Request for better clarification of the background statistics, principal choices and foundation of the D/ISO proposal for draft amendment of R51

Transmitted by the Netherlands

fig 1: Speed distribution in urban traffic as presented by ACEA in GRB 32 informal doc no 4

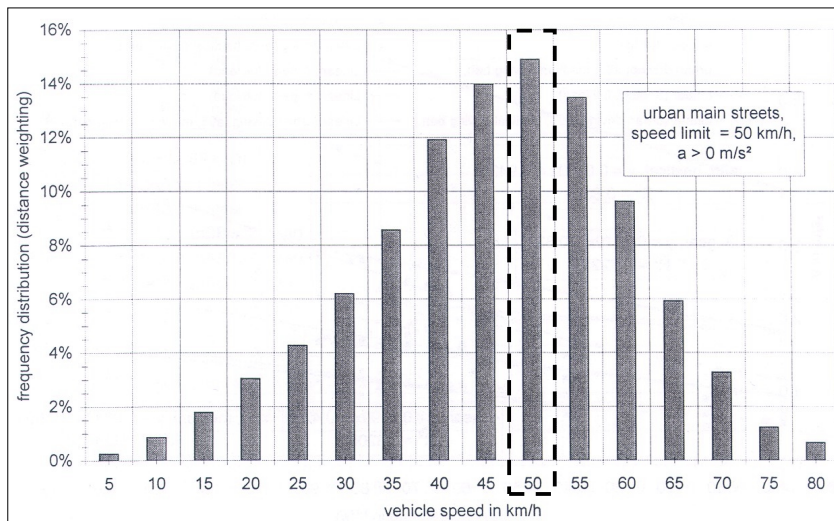
In GRB 32 informal document 9 (page 8) ACEA states that the 50 percentile of vehicle speed is used to ensure the correct choice of driven gear. For the foundation of a test speed of 50 km/h the graph is used which is copied in fig1 below.

Arguments against the use of fig 1:

- Fig 1 is the only analysis which is based on a distribution in % of distance. All other analysis are based on distribution in % of time or % of events.
- Analysis in the distance domain will lead to an over emphasis of high speeds compared to time domain analysis.
- Mixing different units in one analysis may lead to erroneous results.
- Noise is mostly measured in the time domain, seldom in the event domain, but never in the distance domain.

Fig 2 Speed distribution in urban traffic (source JAMA [4])

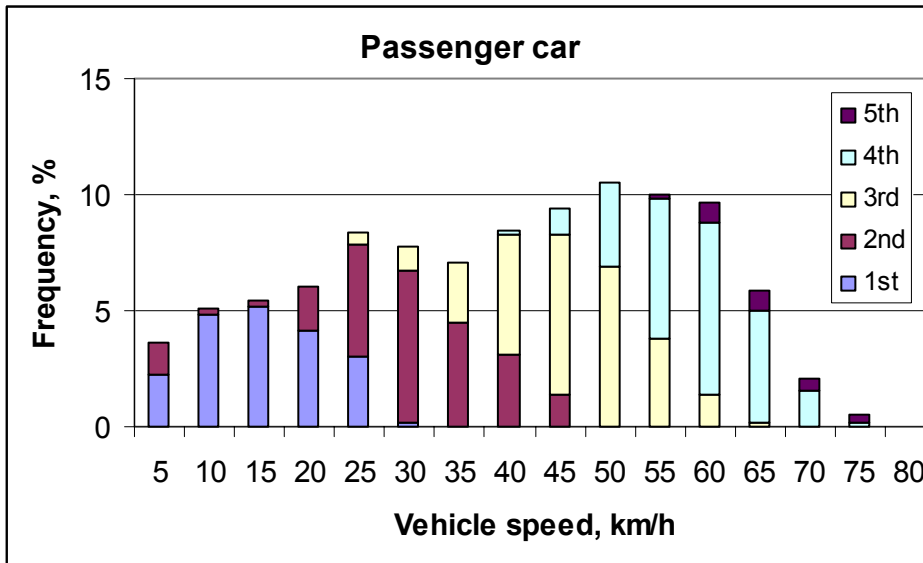
Figs 2 to 5 give examples of other sources of data. All of these data lead to the conclusion that the average urban speed is significantly lower than the test speed of 50 km/h.

In GRB 32; inf doc 9 (page 6) and inf doc 4 (page 5) ACEA shows examples of their analysis of urban driving. Similar examples are given by Le Salver in an Internoise paper [3]. From these data examples the gear use during the urban drive cycle can be extracted. Table 2 gives the percentages. It can be seen that 2nd and 3rd gear are most frequently used in urban traffic. A similar conclusion can be drawn from fig 2.

Fig 3 Speed distribution in urban traffic (a 2D simplification by De Graaff & Van Blokland [7] based on two 3D graphs from Sandberg & Steven [5])

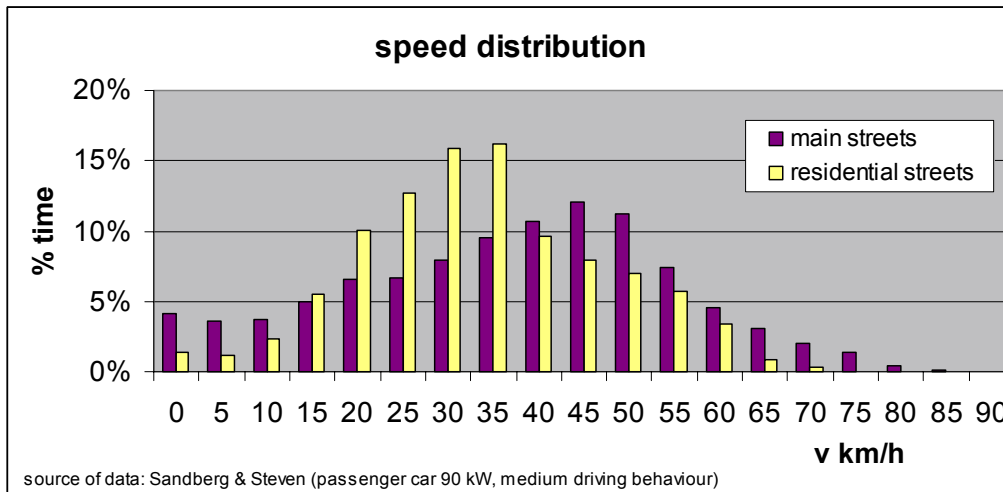
Table 1 gives a classification of drivers in terms of driving behavior. A significant amount of drivers can be stipulated as “faster than most of the others”. Fig 5 shows data for the classification of the total urban network in the Netherlands. It can be seen that urban main streets cover only a minor fraction of the total urban network length. The majority of the urban network consists of residential streets. In fig 3 it can be seen that the speed in residential streets is significantly lower than in main streets.

Fig 5 Categorisation of the total urban road network in the Netherlands; in terms of network length

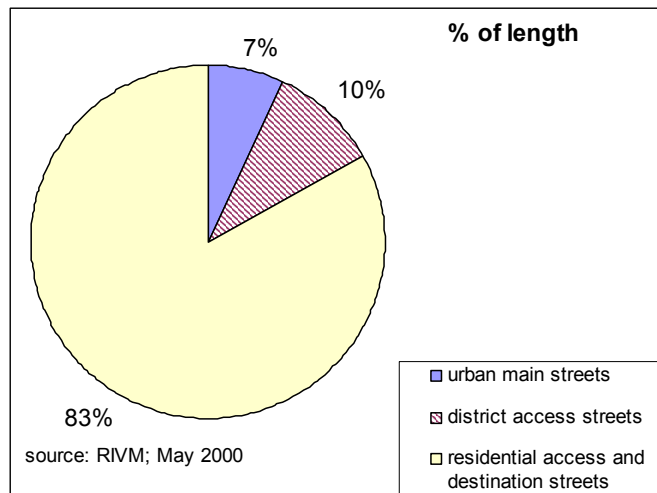
These data lead to the conclusion that a significant amount of urban driving is not included in the targeted test conditions, because

- a significant amount of urban driving occurs at speeds lower than 50 km/h
- a significant amount of urban driving exceeds “normal driving behavior”
